Relicensing Study 3.1.2

NORTHFIELD MOUNTAIN/TURNERS FALLS OPERATIONS IMPACT ON EXISTING EROSION AND POTENTIAL BANK INSTABILITY

Initial Study Report Summary

Northfield Mountain Pumped Storage Project (No. 2485)
and Turners Falls Hydroelectric Project (No. 1889)

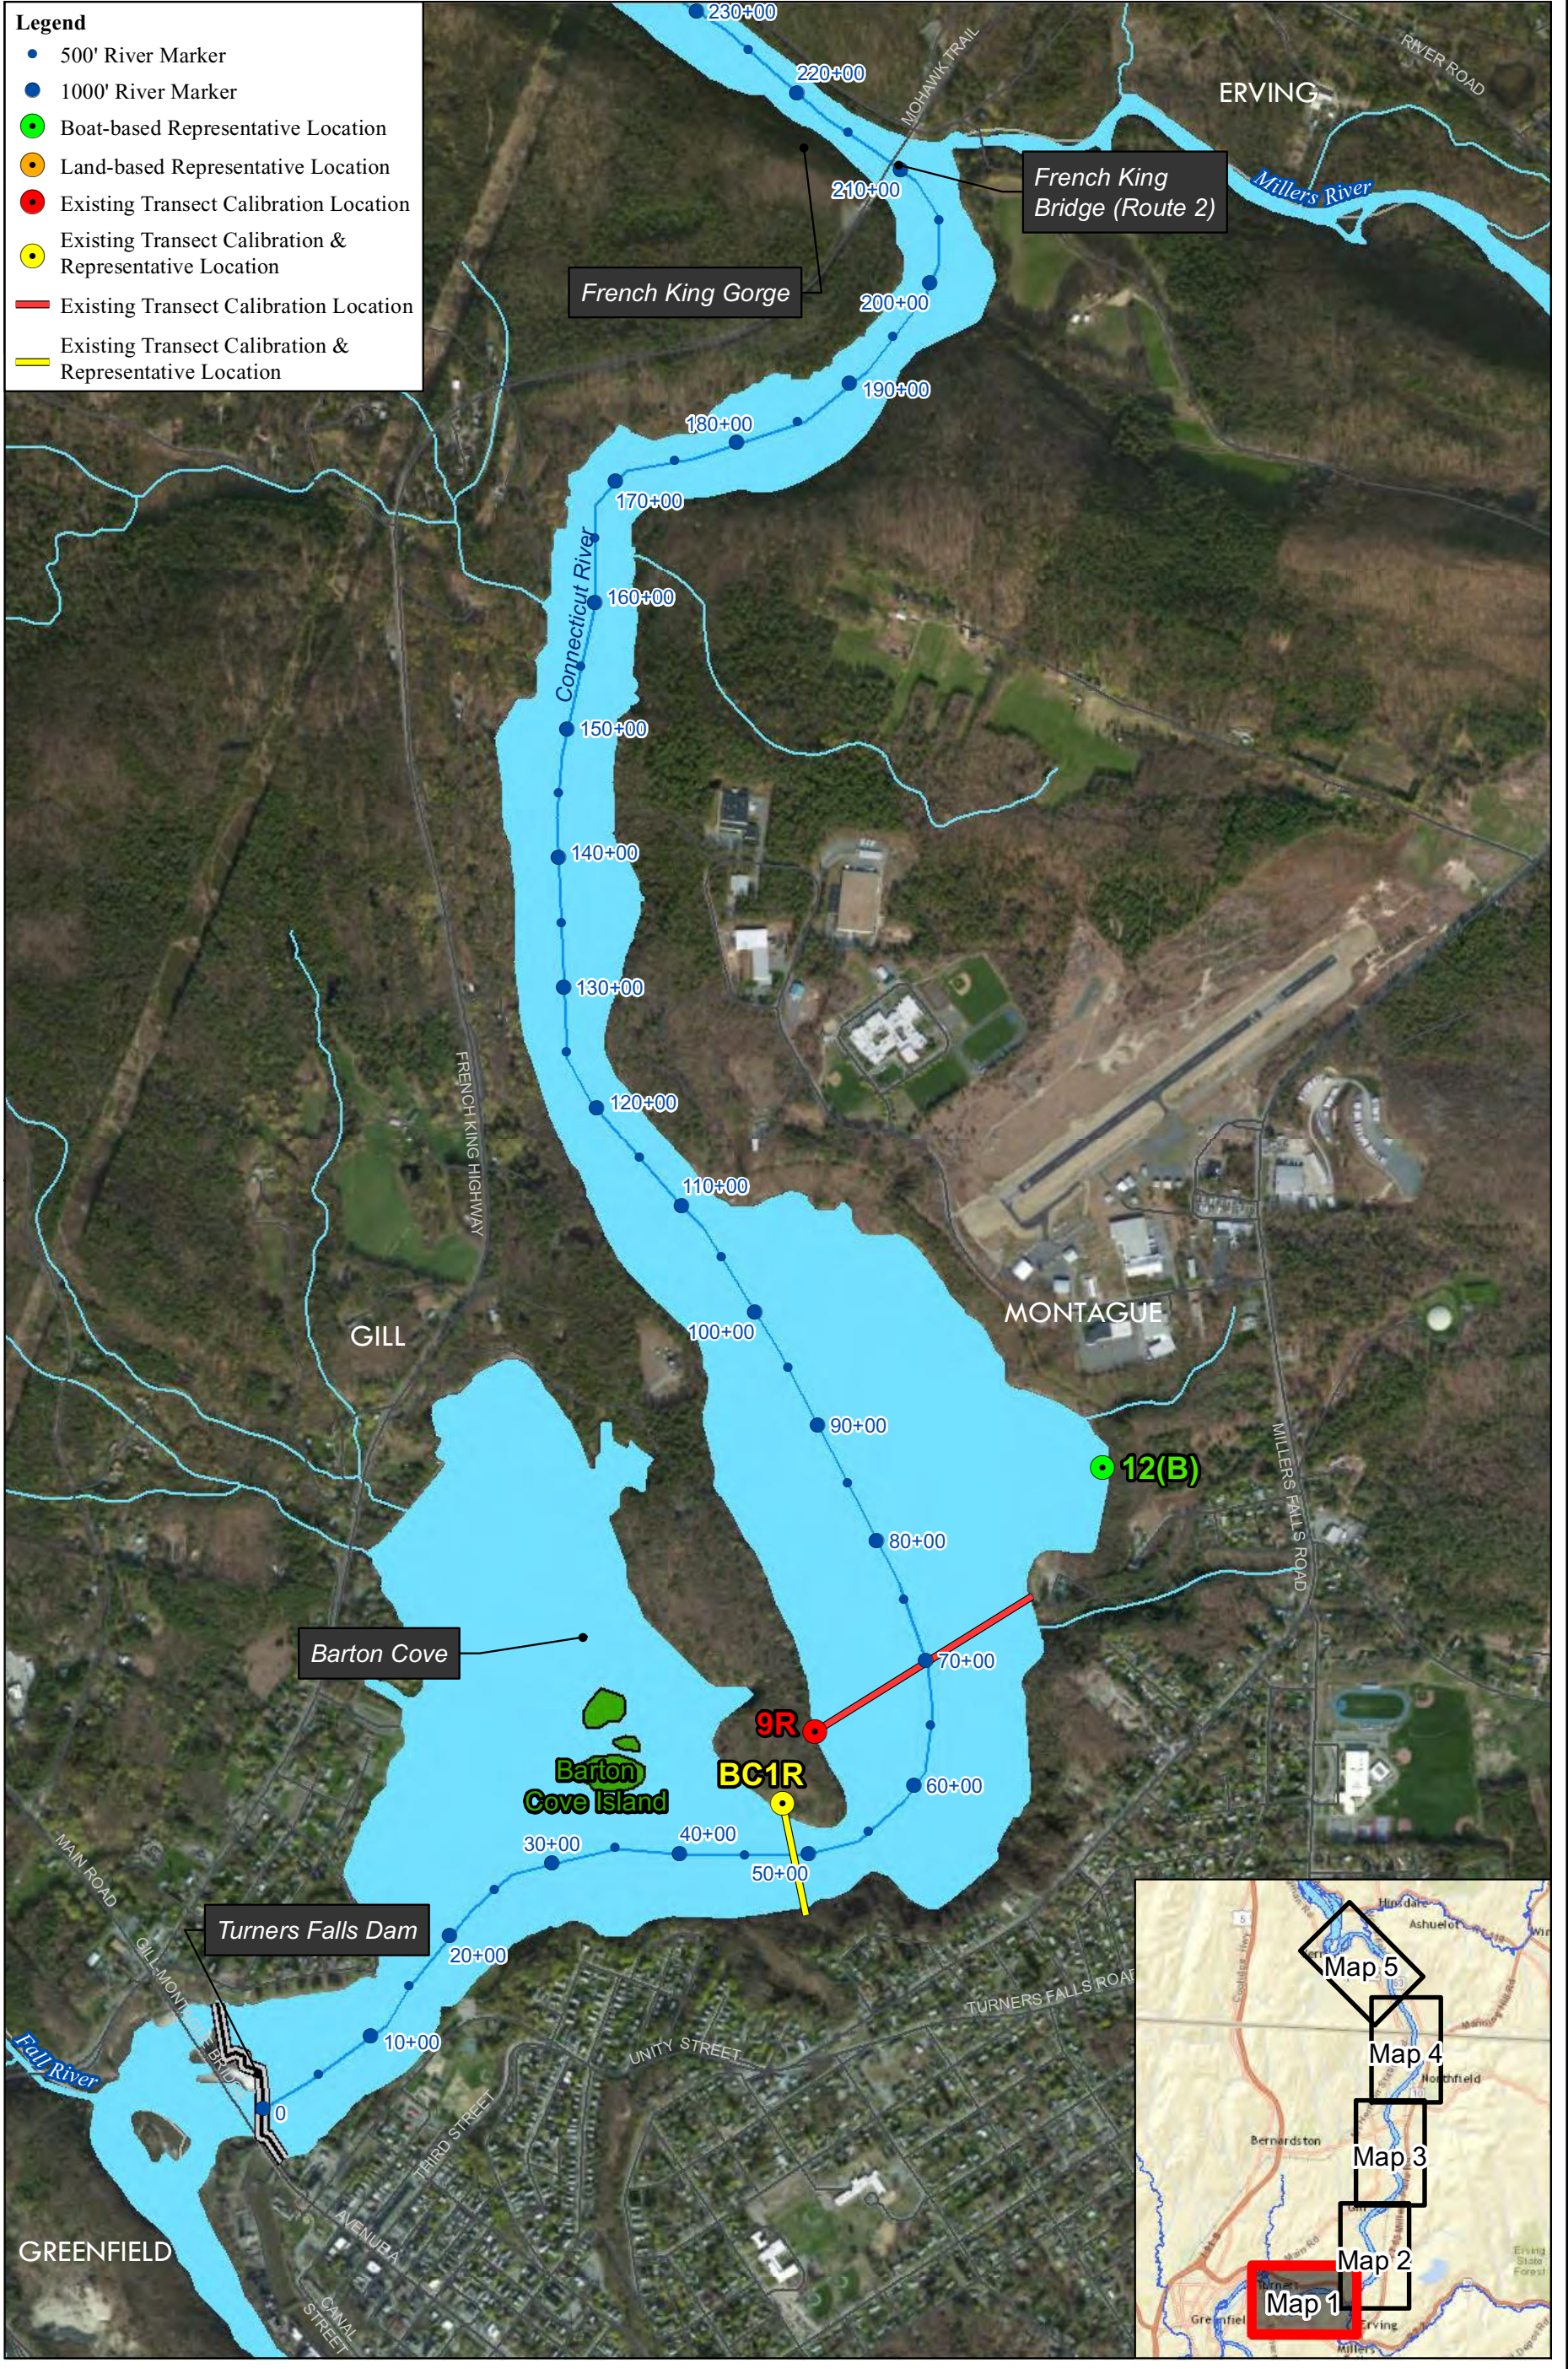
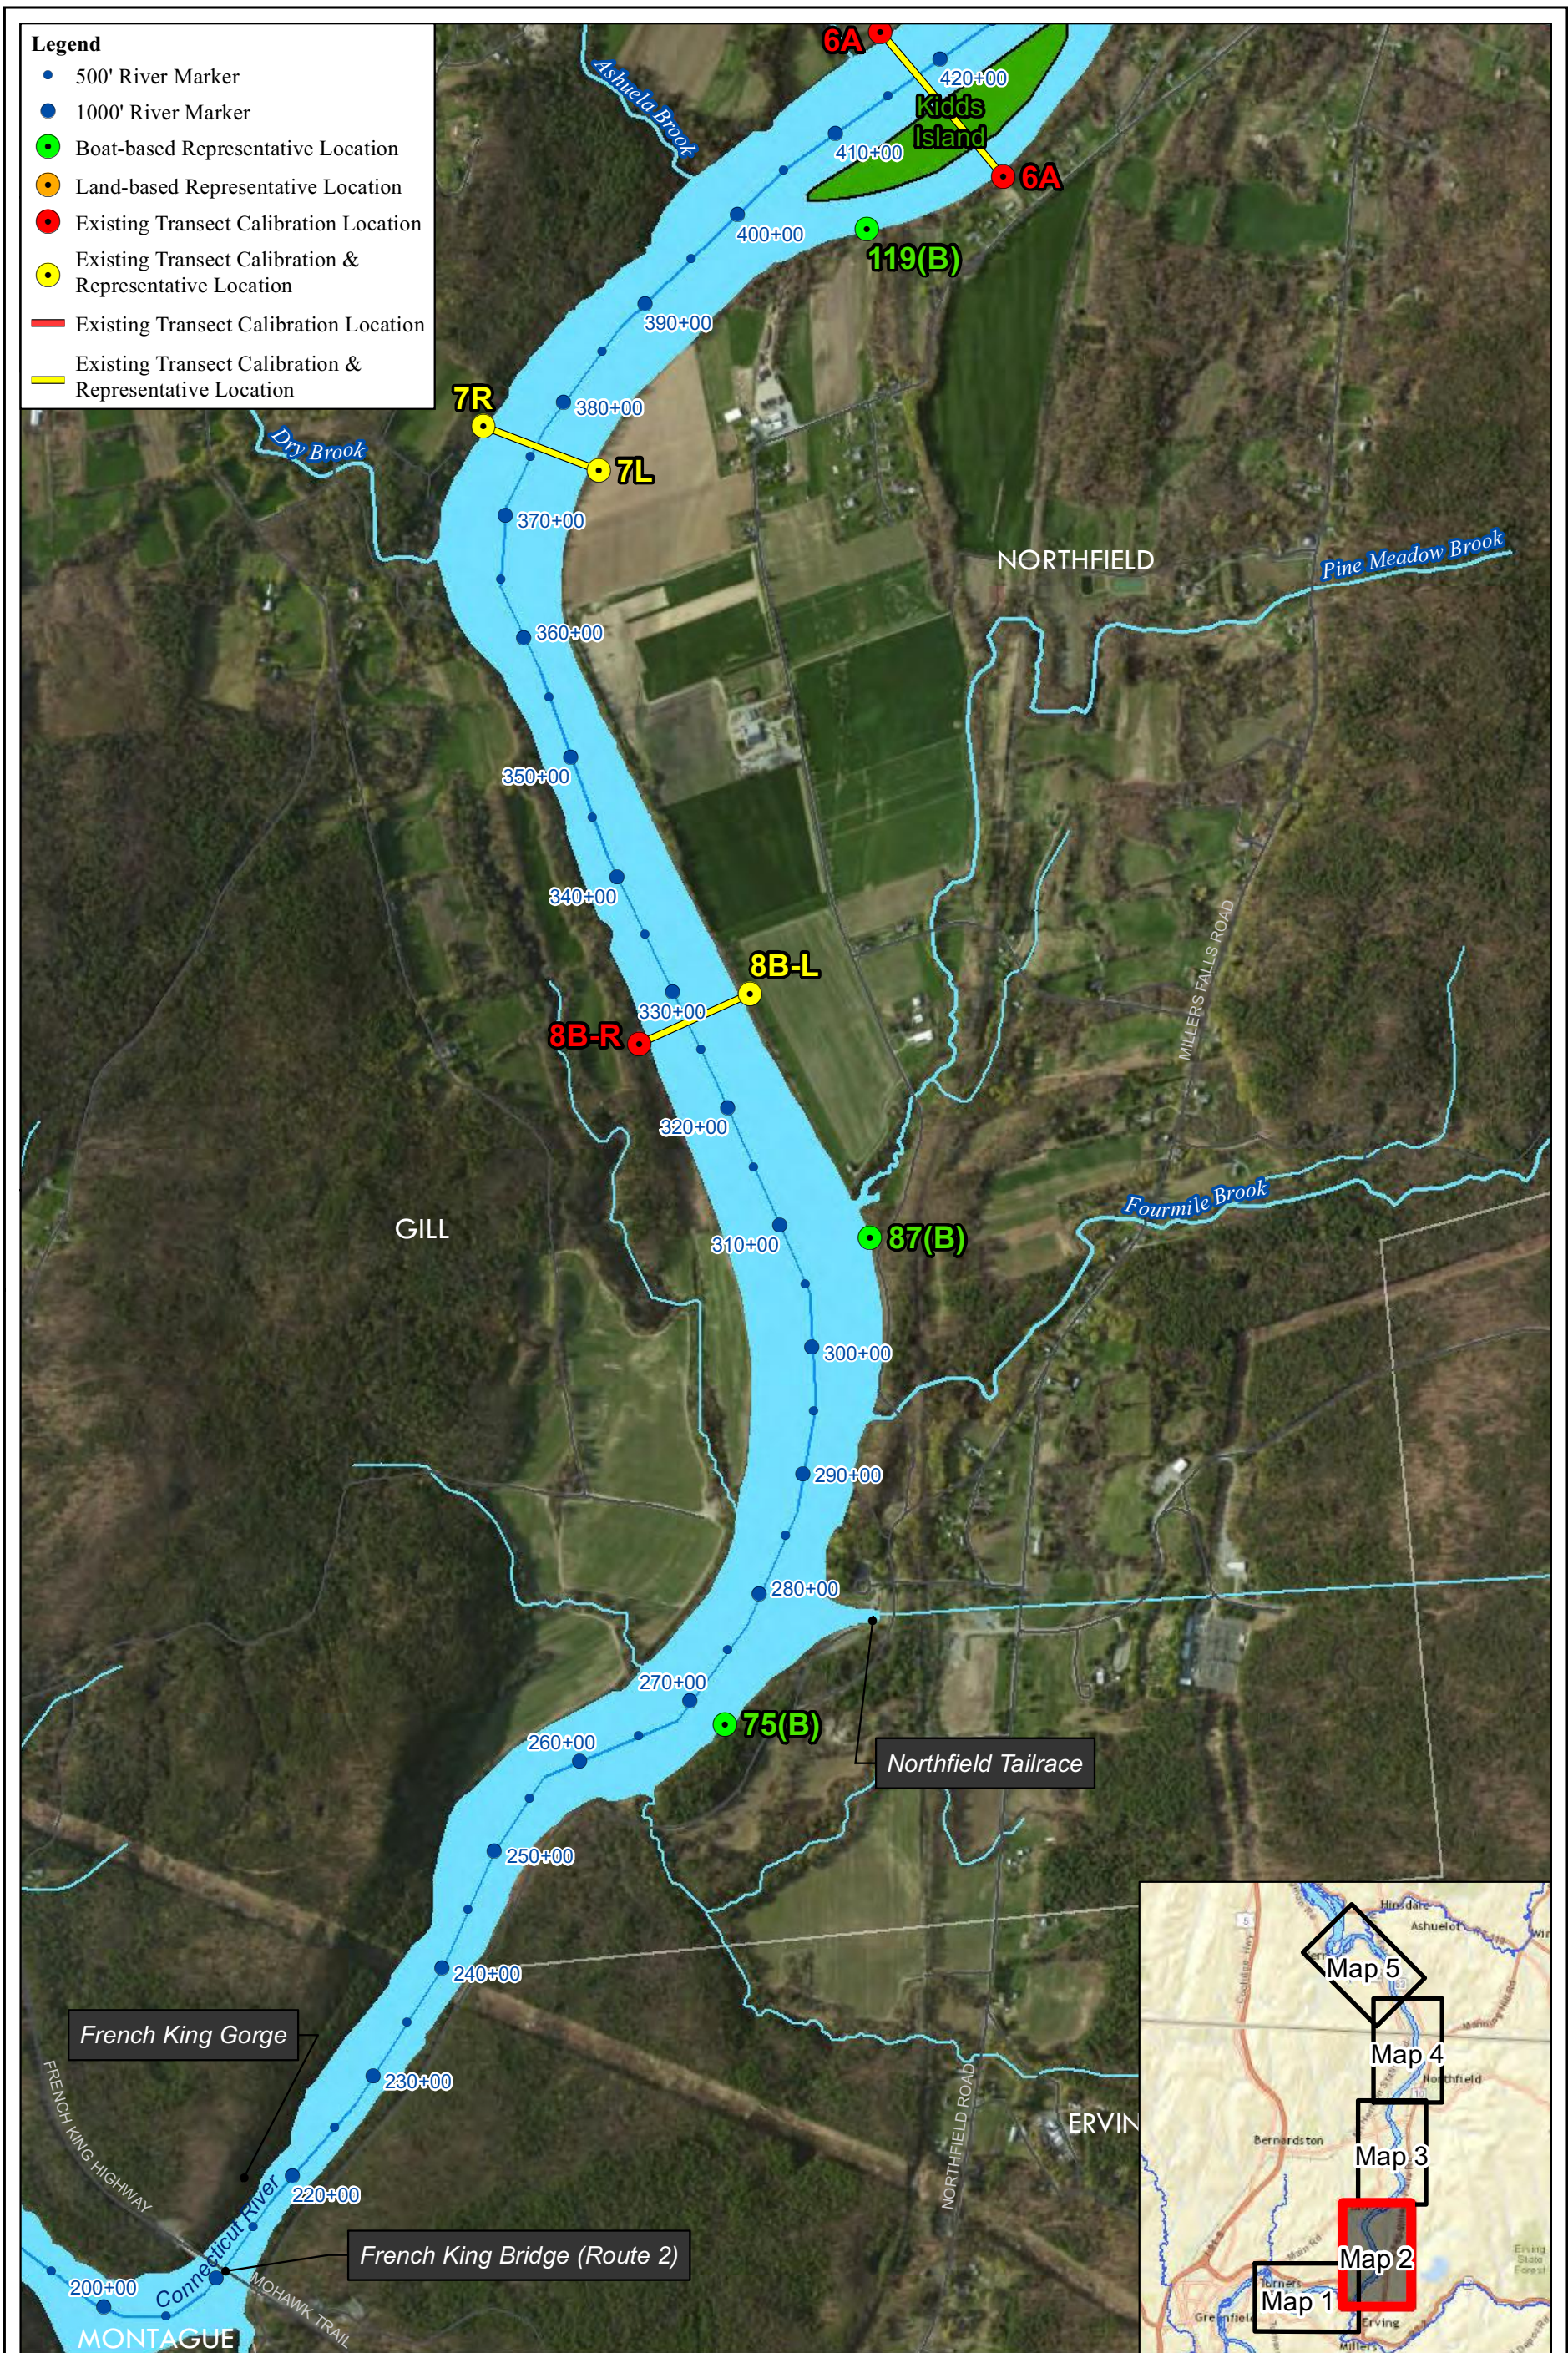
I categorized sites using the Proposed Representative & Calibration Locations for Detailed Study, Figures 7-2 through 7-6 plus one change as presented in Powerpoint at the June 26 meeting.

Comment: The stakeholders compiled a matrix of FirstLight's proposed representative and calibration sites and their locations at an Inside Bend, Outside Bend or Straight Reach. The distribution of these sites should be more even and gaps should be filled. There are plenty of Land-Based Survey locations that could be used to fill these gaps and even the distribution among the morphology types (see last table).

FirstLight has reviewed the letters received to date and has developed the enclosed responsiveness table and associated attachments in response to these comments. Stakeholders raised several concerns about the representativeness of the proposed sites. Concerns were specifically raised in regard to a lack of sites in the vicinity of the Northfield Mountain tailrace and in or near Barton Cove. To address these concerns FirstLight is recommending the addition of sites BC-1R and 87B as well as 303B. Site BC-1R is located on the peninsula entering Barton Cove while Site 87B is located just upstream of the Northfield Mountain tailrace. Site 303B is located downstream of the Ashuelot River confluence and satisfies specific riverbank characteristics requested by the Stakeholders. As explained in the attached documents these

sites will replace Sites 11I, 6A-I, and 90B. More information on this and other Stakeholder concerns can be found in the enclosed documents.
